Groundwater Transfer Review Summary Form

Transfer/PA # T- 14072

Application: T-14072 Applicant Name: Fairview Addition LLC – Cascadia Canyon LLC

Proposed Changes: ☒ POA ☐ APOA ☐ SW→GW ☐ RA
 ☒ USE ☒ POU ☐ OTHER

Cross Section showing FROM-POA MARI 11348 and TO-POA MARI 12553

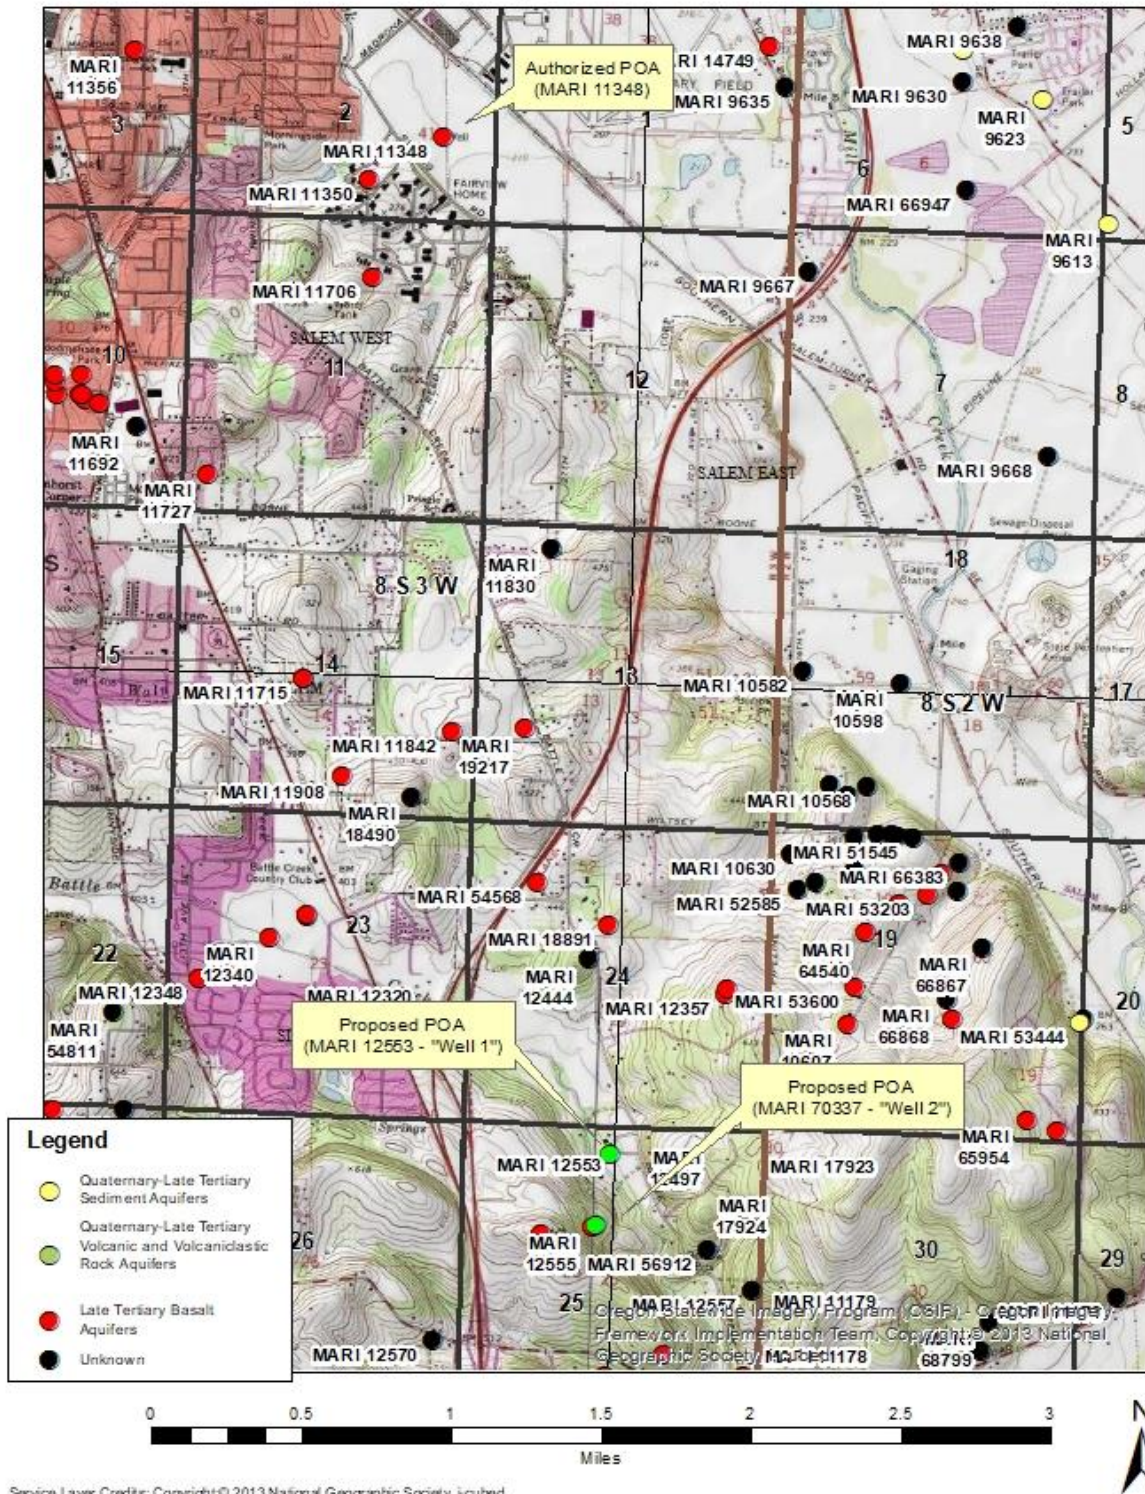
The authorized POA, MARI 11348, is located approximately 3.5 miles north of both proposed POA locations. MARI 11348 is 375 feet deep, and obtains groundwater from water-bearing interflow zones in the Columbia River Basalt Group (CRBG) aquifer system (Gannet and Caldwell, 1998; Conlon and others, 2005; Smith and Roe, 2015). The ground surface elevation at MARI 11348 is approximately 210 ft msl, and the bottom of the well is at about elevation -165 ft msl (see attached map and cross-section).

In addition to being located several miles away, the ground surface elevations at the two proposed POA, MARI 12553 and MARI 70337, are hundreds of feet higher than at MARI 11348, at about elevation 375 ft msl for MARI 12553 and 495 ft msl for MARI 70337. Furthermore, both proposed POA are *significantly* shallower than MARI 11348, at only 68 feet deep for MARI 12553 and 94 feet deep for MARI 70337 (an original log is not available for MARI 70337, but the application indicates a total depth of 94 feet (see Table 3 of application); MARI 70337 is not shown on the attached cross section due to the lack of lithologic information). These conditions place the *bottoms* of both proposed POA wells *about 100 to 200 feet above the ground surface elevation at the authorized POA (MARI 11348) location*; the water-producing zones in MARI 11348 are even more vertically-displaced, ranging from about 350 to 450 feet below the bottoms of both proposed POA. Consequently, the static water-level elevations between the authorized and two proposed POA are also necessarily much different (by at least 100 feet, and perhaps much more), further indicating different aquifer sources at the two locations.

In addition to grossly dissimilar static water levels, the formation description on the MARI 12553 log does not show the presence of basalt; it instead shows clay underlain by “hard blue shale” and “gray limestone” or “limy shale.” Given its location and completion details, MARI 12553 obtains groundwater not from the CRBG aquifer but instead from the Tertiary Marine Volcanics and Sedimentary Rock aquifer system. This particular source aquifer has also been identified in other nearby wells, including MARI 56912 and MARI 12320. Although a lithologic description is not available for MARI 70337, a nearby well log (MARI 12555) shows the presence of clay, basalt, and shale over roughly the same depth intervals, all of which are consistent descriptors for the Marine Volcanics and Sedimentary Rock aquifer system.

From these facts it is concluded that the two proposed POA, MARI 12553 and MARI 70337, do not obtain groundwater from the same source aquifer tapped by the authorized POA MARI 11348.
